Subject: Transportation Consulting Services  
Proposed The Sanctuary at Ashland Mills (40B)  
10-60 Main Street, Ashland, MA

MDM Transportation Consultants, Inc. (MDM) is pleased to provide you with the following supplemental transportation review comments for the above-referenced project. These comments have been prepared based on review of Proponent's response memoranda prepared by Proponent dated April 1, 2025, project coordination meeting with the Town of Ashland department heads on Monday, April 14 2025 via Zoom, and a review of updated Site plans prepared by Bohler Engineering dated March 19, 2025 and documentation provided by Proponent as identified below. To facilitate response by Proponent, review items requiring response are noted in ***Bold Italic***.

434.67'(C)  
 657.66'  
 S36°54'02"E

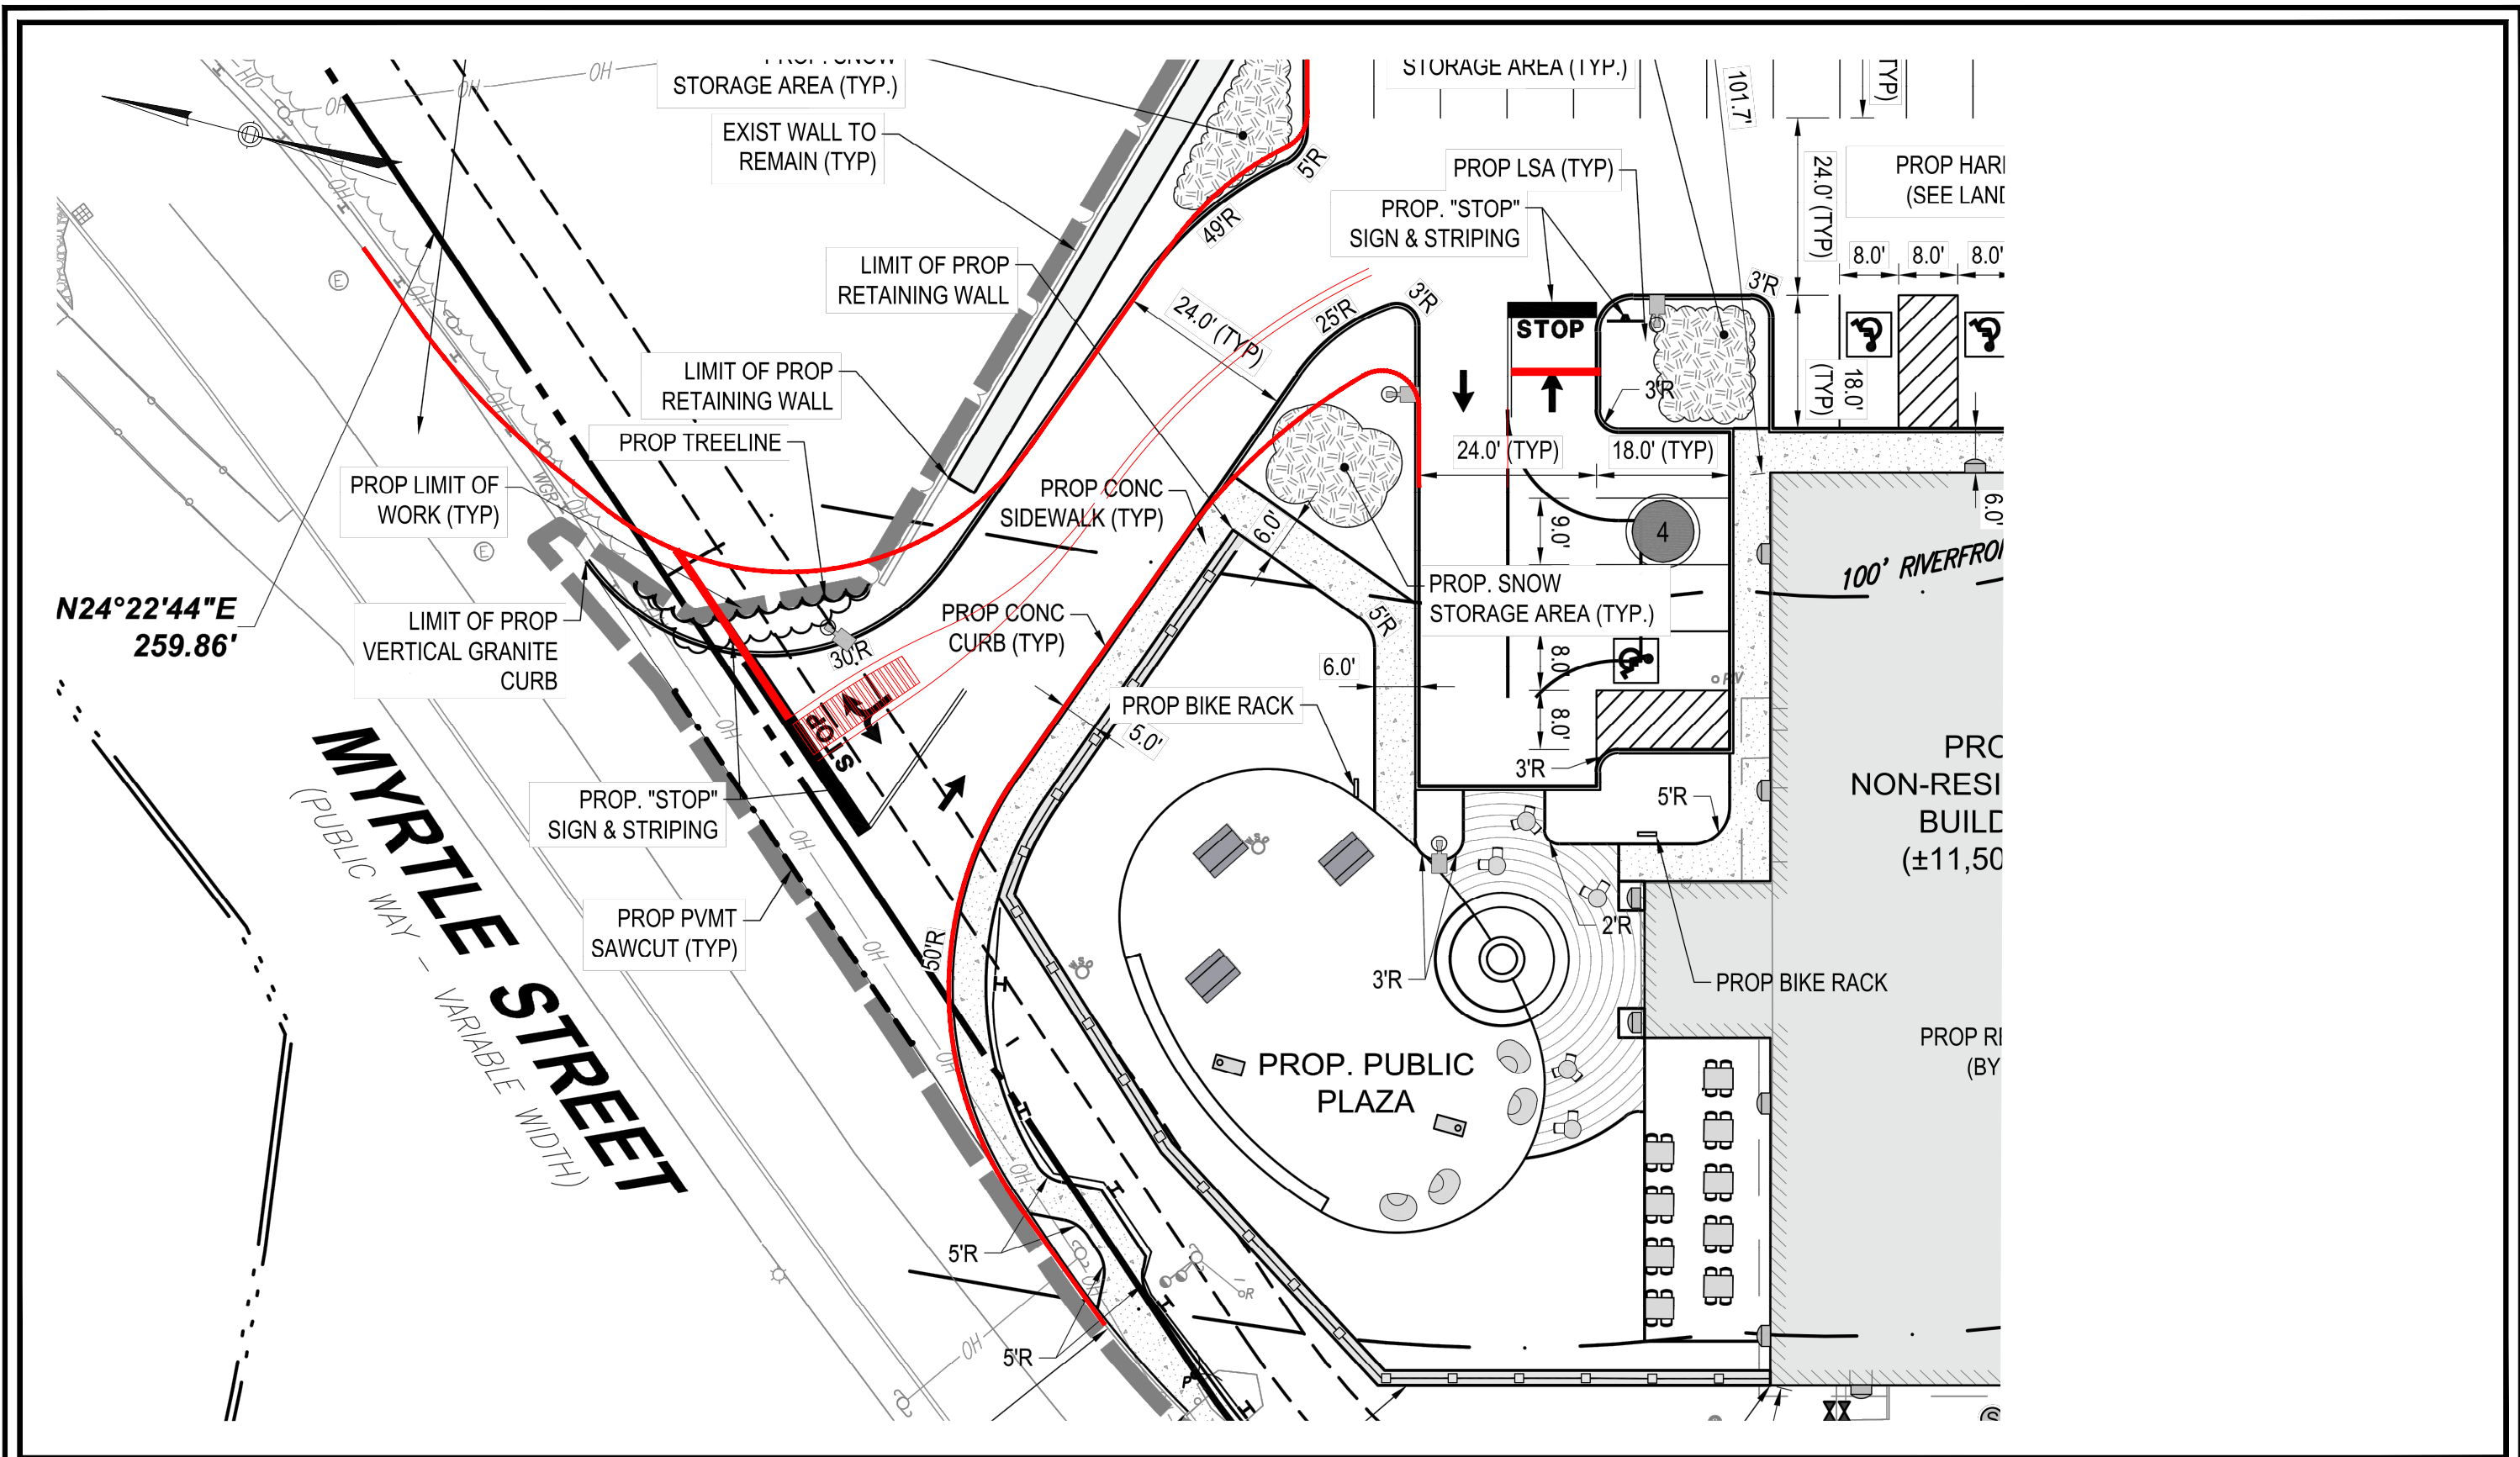
*Final Comment: A review of the AutoTurn exhibits (Single Unit 30, Single Unit 40, and Ladder Truck) indicate that the current design would not properly accommodate fire apparatus and service vehicle swept paths without encroaching into opposing travel lanes at Myrtle Street. Likewise, modification of the Main Street driveway geometry is necessary to properly accommodate vehicle sweeps. Additional input by Fire Department also requires accommodation for emergency vehicle (tower vehicle and ambulance) left-turn existing movement onto Main Street. Refer to attached redline plans prepared by MDM which*

*Final Comment: A review of the AutoTurn exhibits for service vehicles (Single Unit 30 and Single Unit 40) indicate that the current design would not properly accommodate service vehicle swept paths without encroaching into opposing travel lanes for movements into and out of the Driveways. MDM recommends modification to both driveways to accommodate the service vehicles for the Site. Refer to Comments 3(b) and 12(b) for detailed commentary. Refer to Comment 12(d) for recommendations relative to move-in/move-out vehicle staging.*

*Supplemental Comment (March 24, 2025): MDM does not concur that the driveway as proposed meets applicable design requirements for service, delivery, move-in or fire apparatus maneuvering whether these movements occur peak or non-peak. The skewed driveway alignment requires for each of these vehicle types a wide sweep into the opposing travel lane of Myrtle Street or (for entering movements) a wide sweep into the exiting lane of the driveway. This presents a significant safety concern that must be addressed by modifying the driveway alignment and/or adjusting curb radii so that movements do not impact opposing travel. See attached swept path exhibits which illustrate swept paths for various vehicle types based on currently proposed driveway design.*

*suggest (in concept form) the geometric changes necessary to address vehicle swept path movements and Fire Department maneuvering requirements. Design modifications include wider driveway lanes at Main Street with additional scored concrete panels and adjusted curb radii. The Myrtle Street driveway design modification include shifting the driveway alignment north with enlarged curb radius to accommodate right-turn movements by service and emergency apparatus. Shifting the Myrtle Street driveway alignment north would have the added advantage of increasing sight distance to Main Street by approximately 20-30 feet, thereby ensuring that more than the absolute minimum SSD criteria may be met for the driveway.*
